Interactive comment on “Reliability of meteorological drought indices for predicting soil moisture droughts” by D. Halwatura et al.

D. Halwatura et al.

Received and published: 13 November 2016

Fig. 1. Correlations between simulated monthly minimum soil moisture in 5 cm soil depth vs SPI and RDI. The scatter plots represent the correlation for each location.

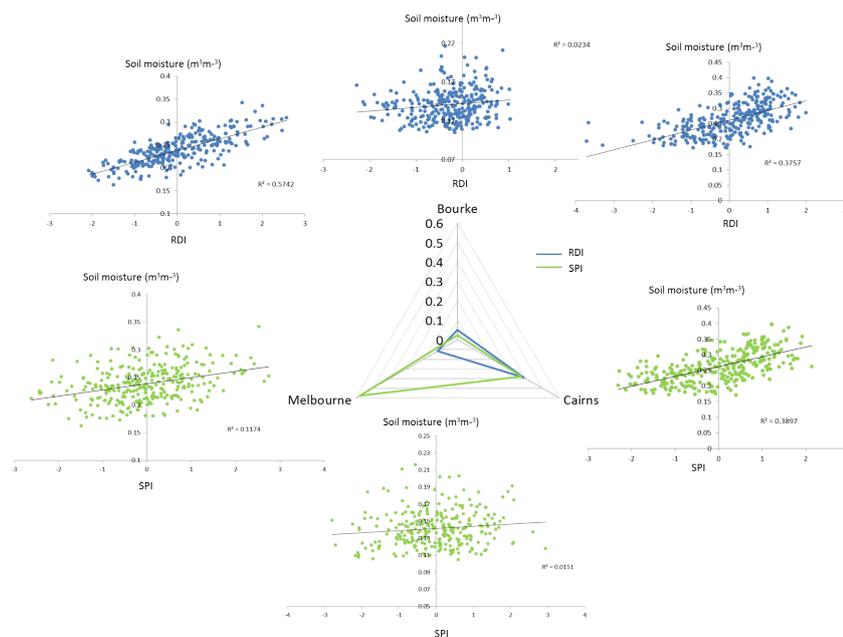
Comment 1: As the key idea about the research is testing the ability of meteorological drought indices in predicting soil drought. Why only use soil water pressure to quantify the ‘soil moisture droughts’? I suggest the author should use the observed soil moisture to test the capability of these drought indices. You may not use the SM data of all layers studied, at least the average condition of SM and its correlation with the drought indices should be revealed. Comment 2: As agricultural drought or eco-drought are

usually measured by soil moisture. The relationship between soil moisture and soil water pressure used in current research should be further studied in the 3 stations.

Response 1 & 2: We use soil water pressure over soil moisture as this allows us to examine potential water fluxes between plant roots and the soil water storage. Only water pressure provides the relevant information to assess water availability for plants, which is required for estimating agricultural droughts. The unique relationship between soil water pressure and soil moisture is described by the water retention curve (Table 2 in manuscript). Implicitly, water retention characteristics are usually fundamental to soil moisture based indices such as the soil water deficit index (Martínez-Fernández et al., 2015). As the soil water retention curve is monotonic, we have no reason to believe that the use of soil moisture over soil water pressure would affect our findings on the false alarm (FAR) and failure rate (FR). However, we acknowledge the role of soil moisture defining the total store of water and provide the web plots of correlations between soil moisture and drought indices (Fig. 1 below), as well as the corresponding simulated time series (Fig. 2 below). We do not propose to include these Figures in the paper, but we thought useful to show these for the review process.

Fig. 5. Correlations between simulated monthly minimum soil water pressure (pF) vs SPI and RDI for 5 cm and 30 cm soil depth at a 1-, 3- and 12-monthly timescale, respectively.

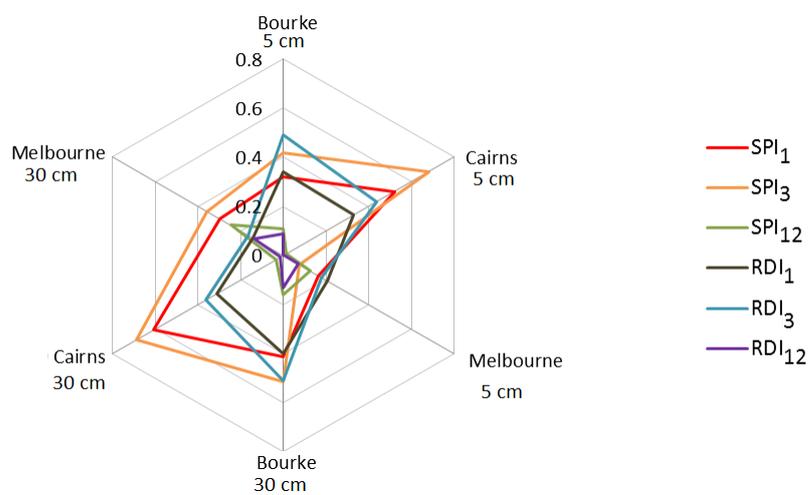
Comment 3: I suggest the author also analyze the effect of drought timescale on soil moisture. You may analyze more on soil moisture and drought with changing timescales e.g. 1-12 months.

Response 3: “The SPI and RDI were calculated using climate inputs averaged over one, three and twelve month time periods. However for the sake of simplicity and to keep the paper length reasonable we present only the results based on the three month time period” (manuscript P3L25). The correlation was most significant at the 3-monthly timescale and qualitatively the same across all timescales (Figure 3, not included in paper).
